Rural Electric Cooperative Corporation

RE: PSC Case No. 2010-00518

Amendment To Current Approved  
Construction Work Plan

Amendment # **2012-3** Borrower Designation **KY 51 (Nolin RECC)**

# CFR 336

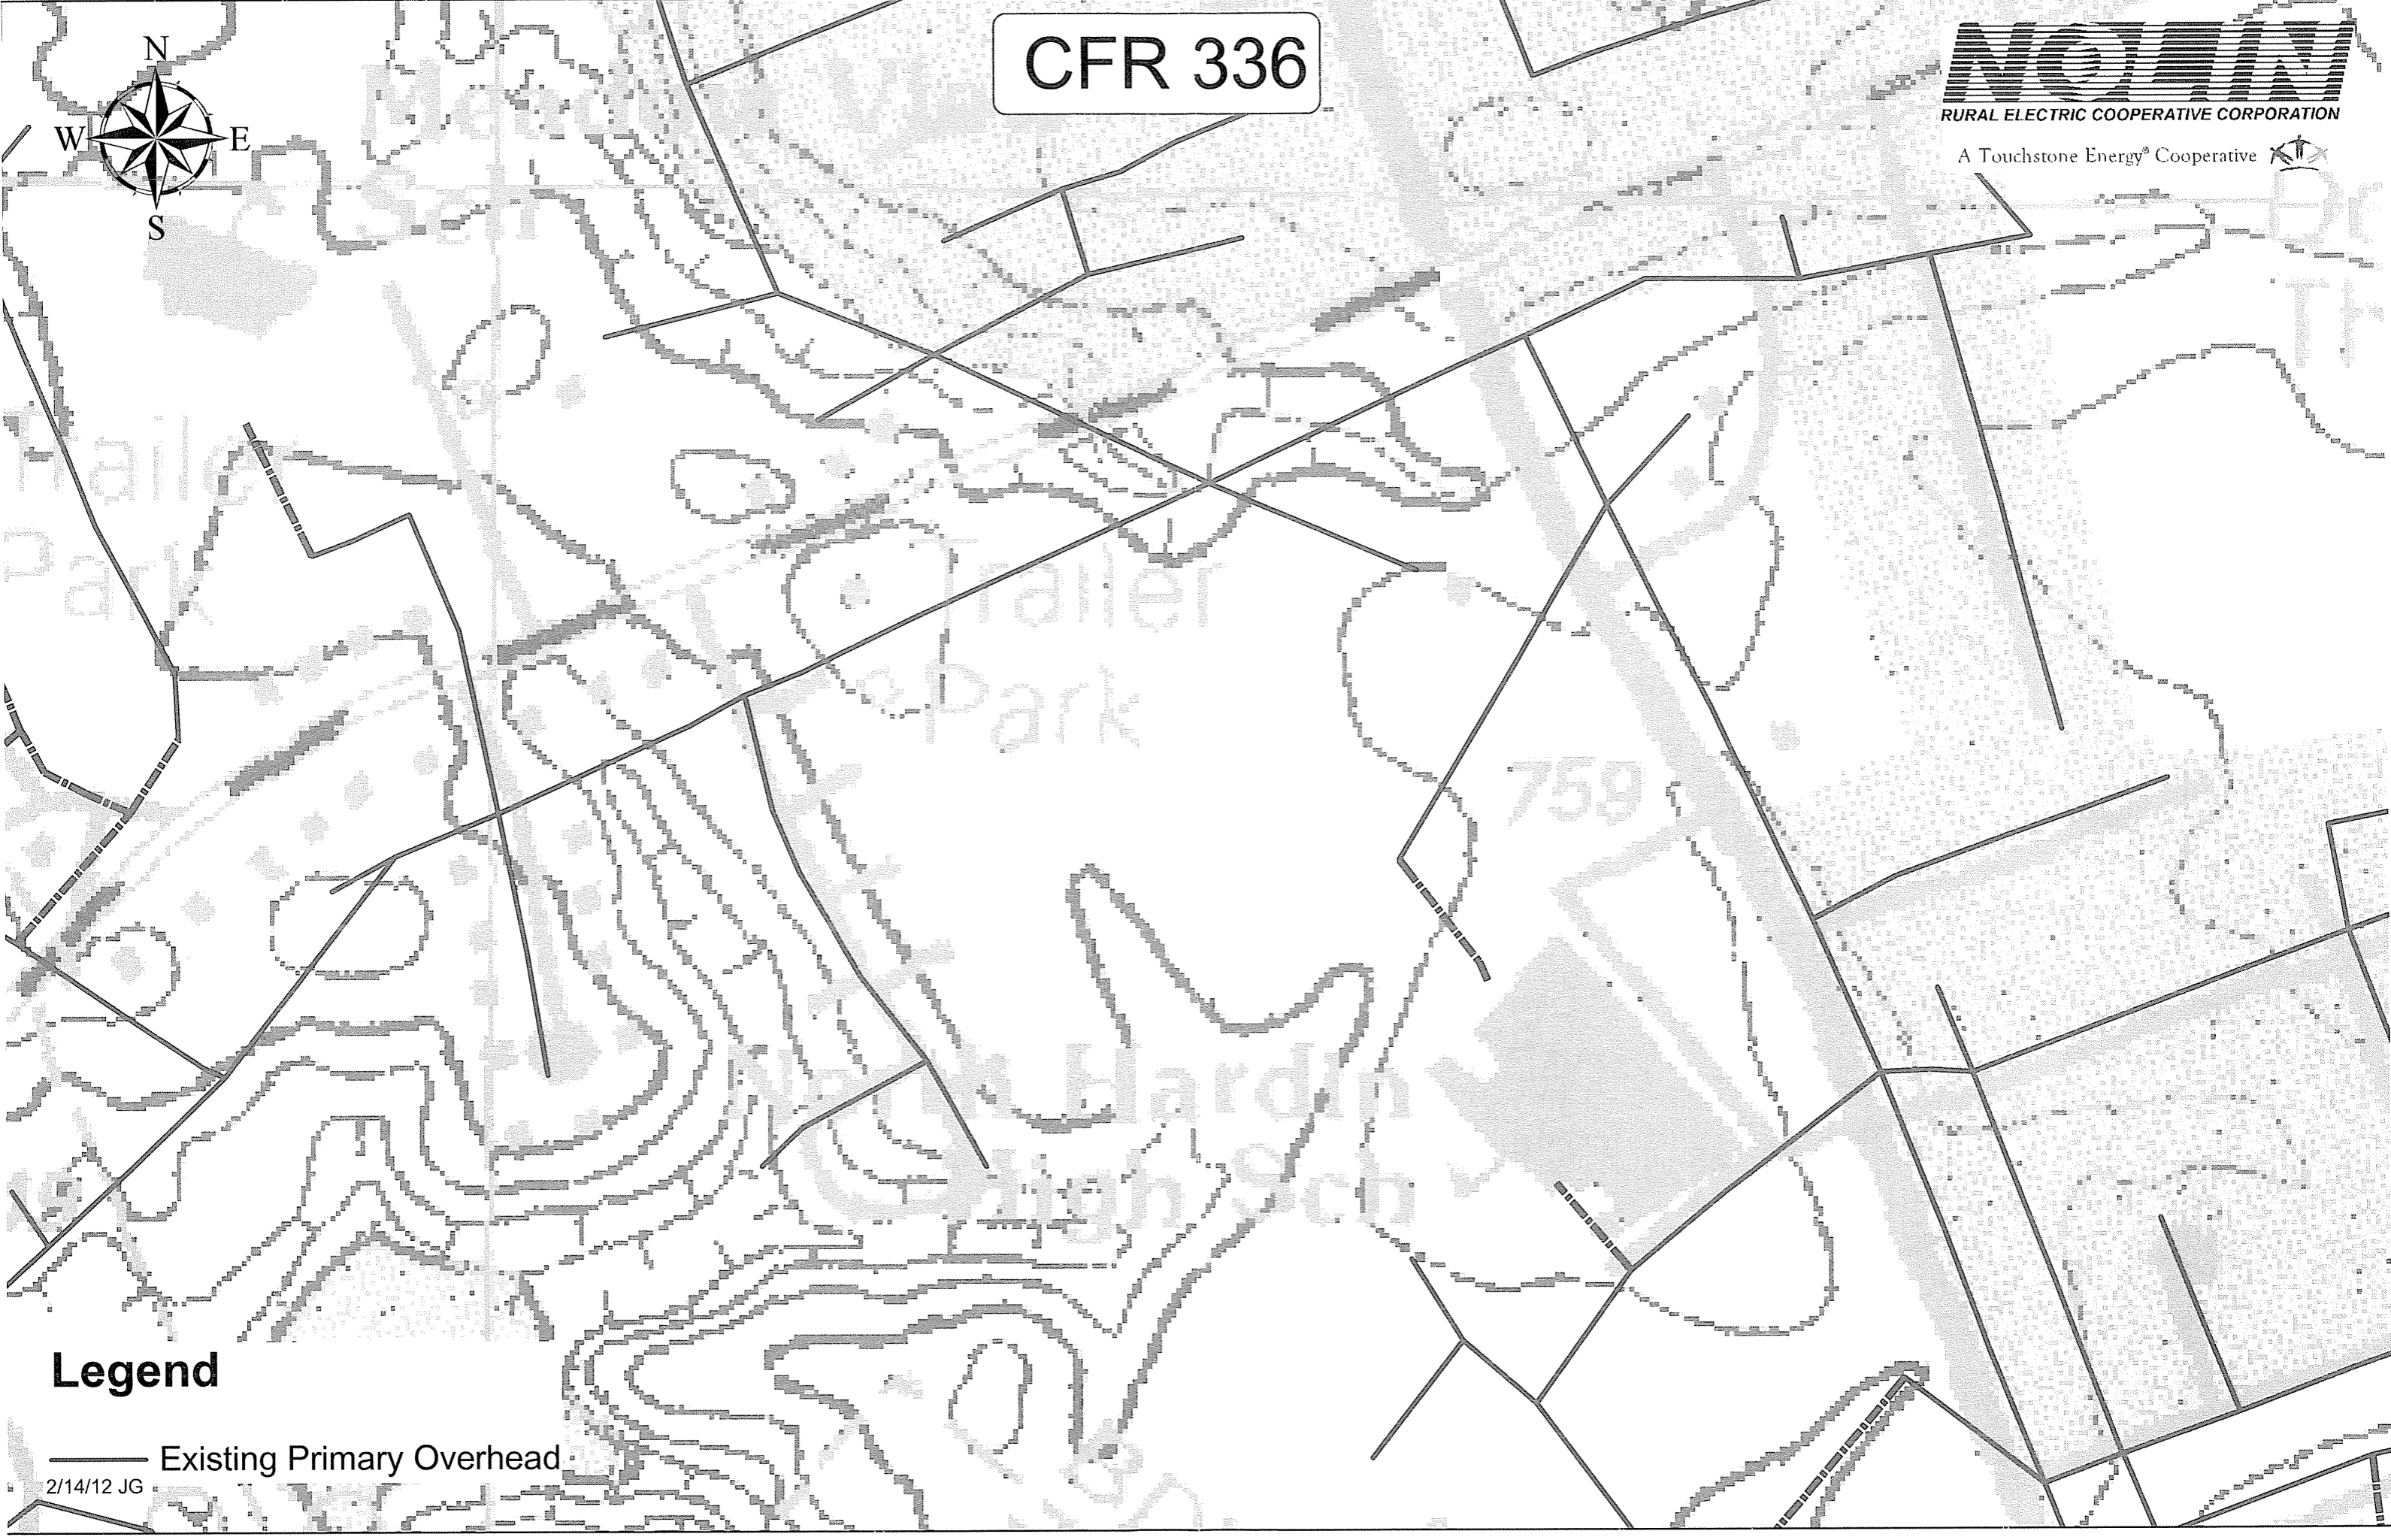
Relocate a section of existing .4 miles of three phase #336.4 ACSR and place taps of single phase off the main line totaling 1.6 miles of 1/0 STR Al and serving 13-100 kVA transformers. The new apartment complex is located near the corner of West Vine and Logsdon Parkway in Vine Grove, Kentucky.

The new apartment complex is Phase 1 of The Parks of Vine and will add approximately 78 members. The line will provide a better balance of the phases, improve outage time from trees and provide for future development of the other Phases.

# CFR 337

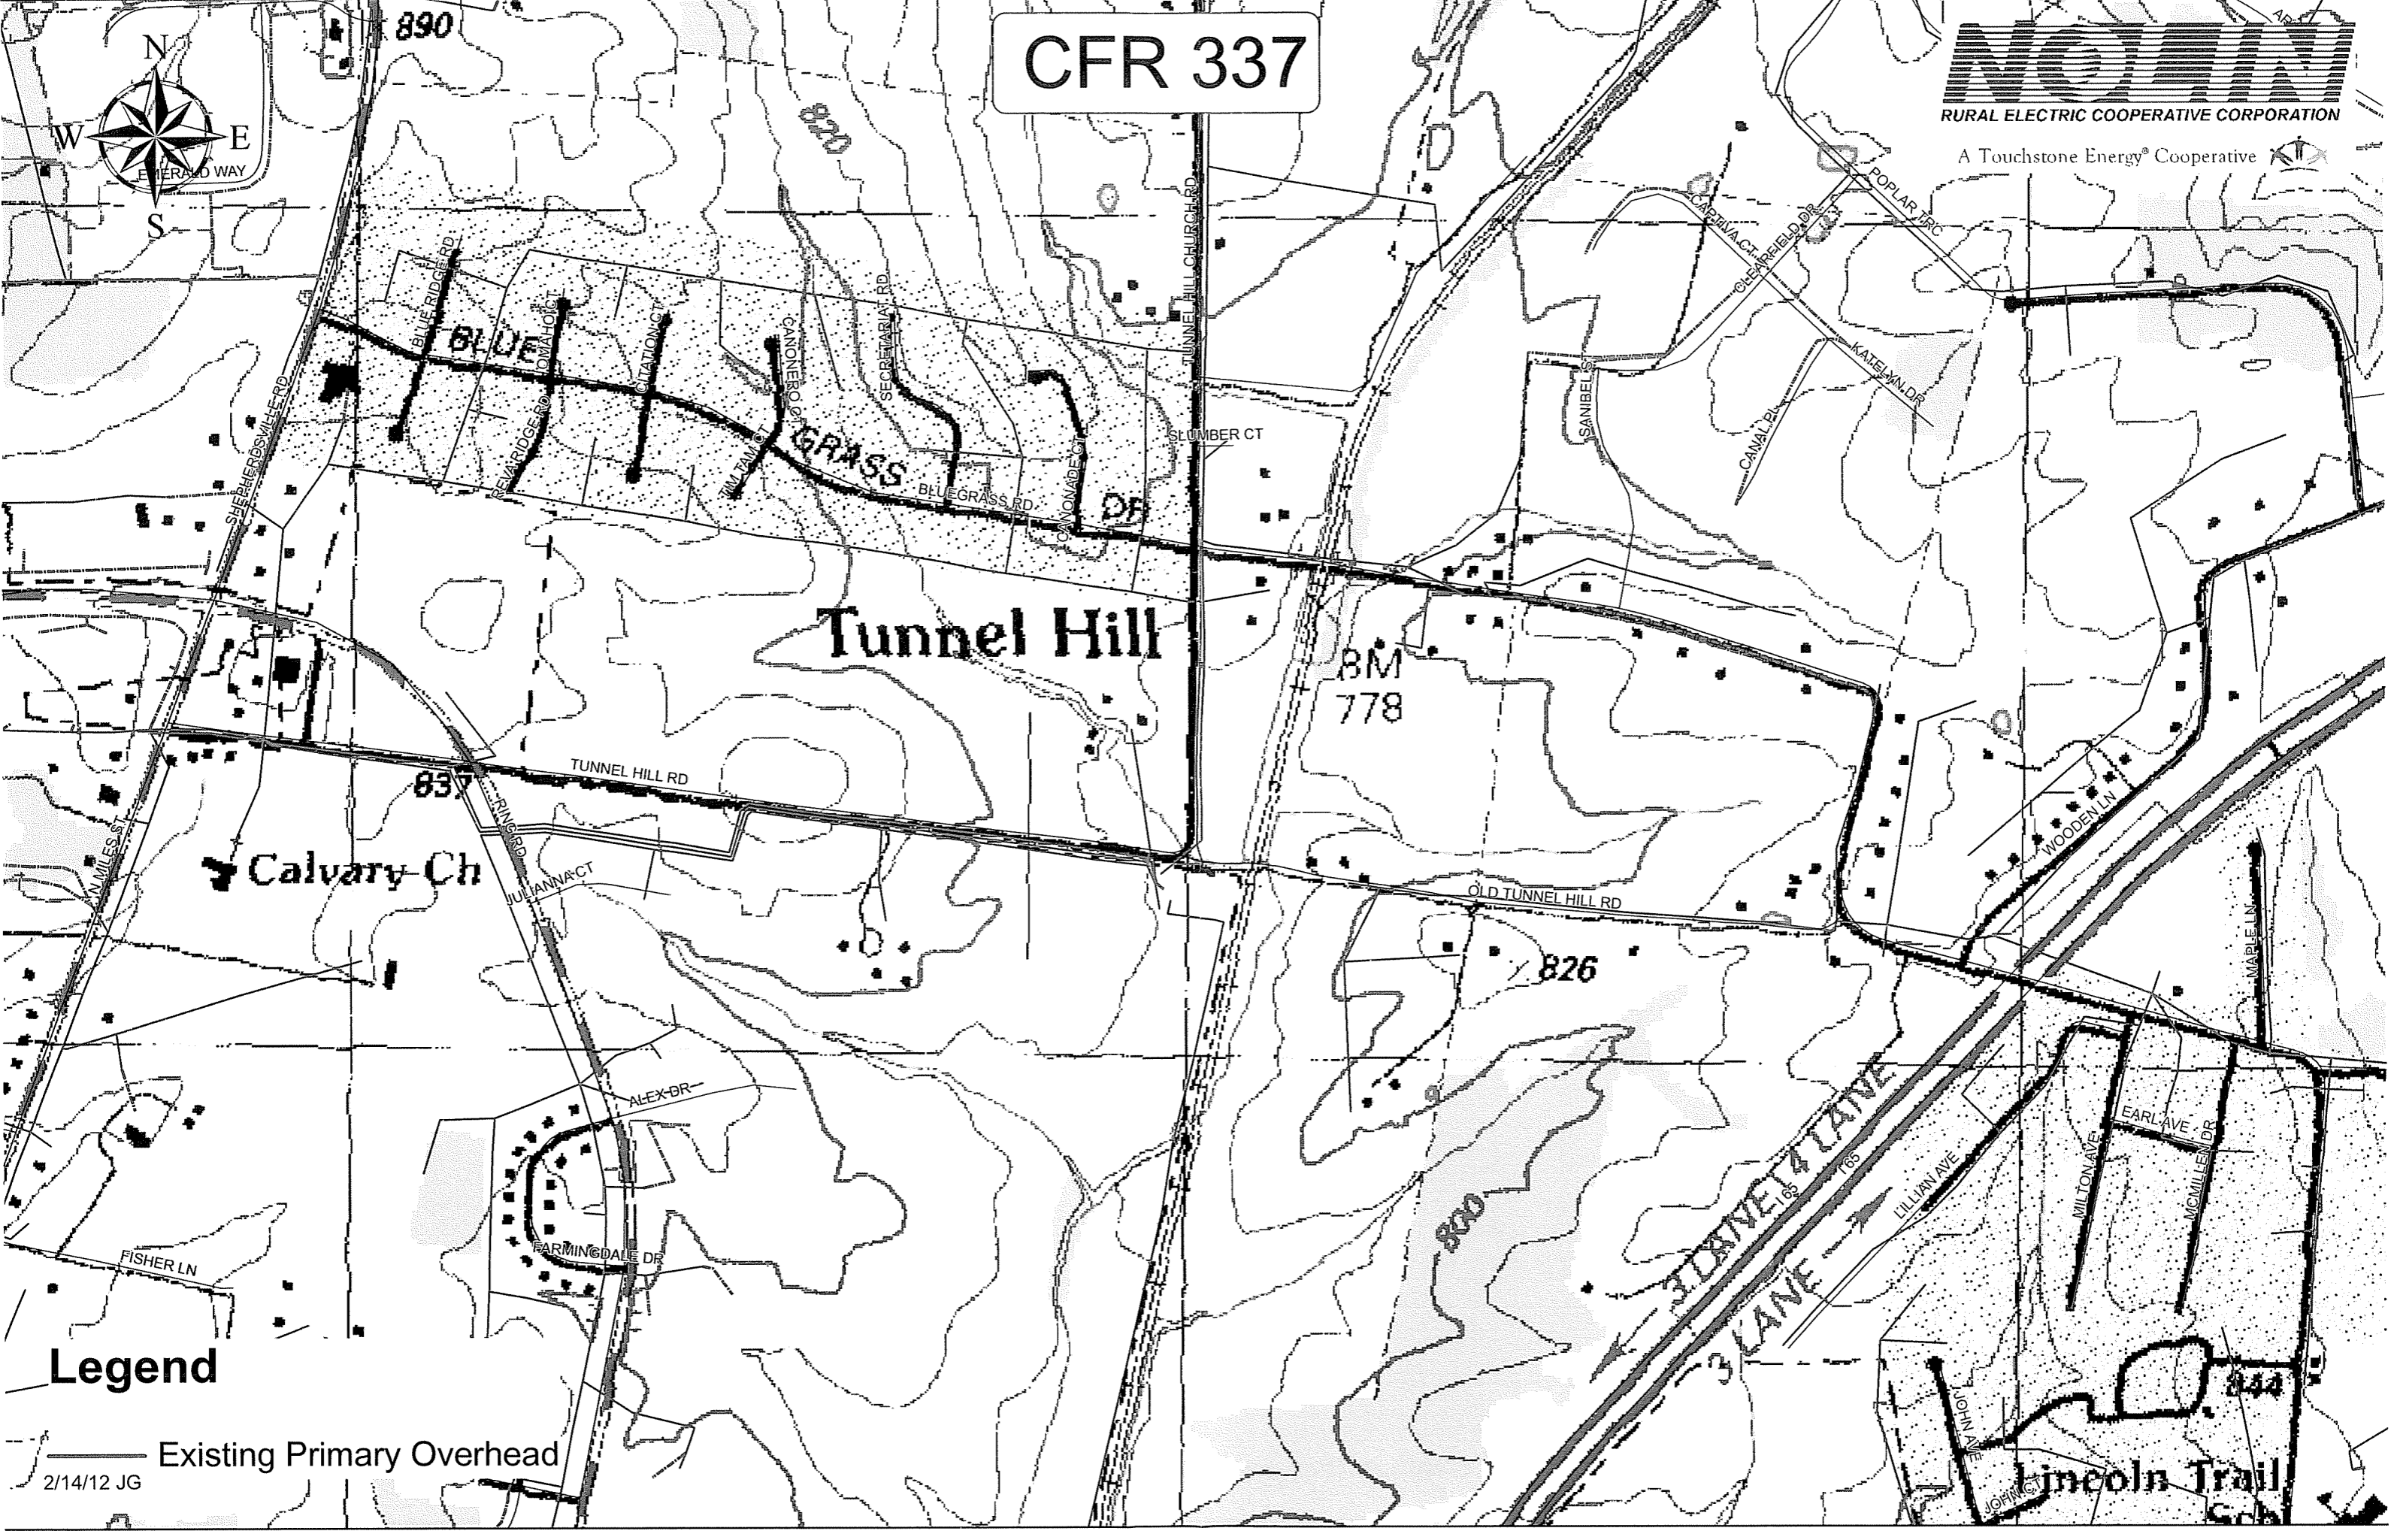
Tap an existing three phase #336.4 ACSR with 0.4 miles of a three phase 4/0 Al STR AL URD and place taps of single phase off the main line totaling 0.6 miles of 1/0 STR Al and serving 8 transformers of multiple size and configurations. The new complex is located near the corner of Ring Road and Tunnel Hill Road in Elizabethtown, Kentucky.

The new complex will add approximately 78 members. The line will provide a better balance of the phases, improve outage time from trees and provide for future development of the other Phases.
